AGENDA ITEM SUMMARY REPORT

APPLICATION NO.: CDP 8-19, DR 1-19, MGR 1-19

PROJECT: A Coastal Development Permit, Design Review and Notice of Merger to construct a Grocery Outlet Market (retail store). The project includes the demolition of an existing 16,436-square-foot vacant former office building and associated 47-space parking lot and wooden fencing along the property line, and the construction and operation of a 16,157-square-foot, one-story, retail store with a 53-space parking lot and associated improvements and infrastructure. The project would be operated by 15 to 25 full-time staff and two (2) managers and would be open from 9:00 AM to 10:00 PM, 7 days per week with two (2) different shifts covering operating hours.

LOCATION: 825, 845, & 851 S. Franklin Street

Figure 3-3 Required Traffic Safety Visibility Area excerpted from 17.30.060

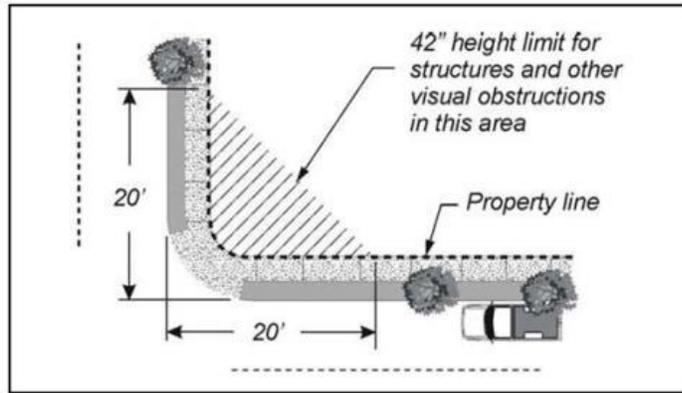
2. Planning Commissioners expressed concern that elements of the project were within the Traffic Safety Visibility Triangle(s) on South St. and South Franklin St. and at the corner of North Harbor Dr. and South Franklin St.

Response: In section **17.30.060E** of the **CLUDC**, it states, development proposed adjacent to any public or private street or alley intersection, or the intersection of a driveway with a street, in other than the Central Business zoning district shall be designed to provide a traffic safety

visibility area for pedestrian and traffic safety as demonstrated in **Figure 3-3** reproduced below. According to **17.30.060E1(a)**, the visibility area shall be defined by measuring 20 feet from the intersection of the front and street side right-of-way lines (i.e., edge of pavement or curb), and connecting the lines across the property.

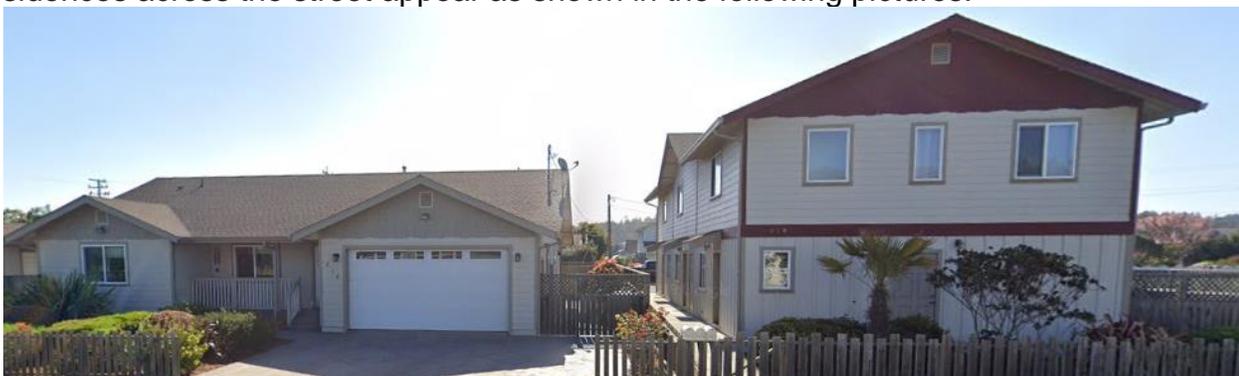
5. At the previous meeting planning commissioner(s) expressed concerns about **Policy CD-1.1: Visual Resources:** Permitted development shall be designed and sited to protect views to and along the ocean and scenic coastal areas, to minimize the alteration of natural landforms, to be visually compatible with the character of surrounding areas, and, where feasible, to restore and enhance scenic views in visually degraded areas.

If you look very closely there is a very small strip of blue in between the cars and the trees and the gas station. However, this is by no means a direct scenic view of the ocean as it can only be seen through significant obstructions and across main street. The General Plan and CLUDC, provide additional definitions by what is meant as visual resource and necessary for analysis. Based on a thorough review, this location is appropriately excluded from those locations intended by the guiding documents. There are at least four public access points

This existing view is “obstructed” and even if it were not obstructed by the gas station and the landscaping, the view would be minimal. After additional discussions with the architect, they explained that moving the location of the building to the North Harbor Dr. side would impact the ability of large trucks to move in and out of the parking lot and stated that it is not a reasonable alternative when site circulation, landscaping, and required parking are to be met.
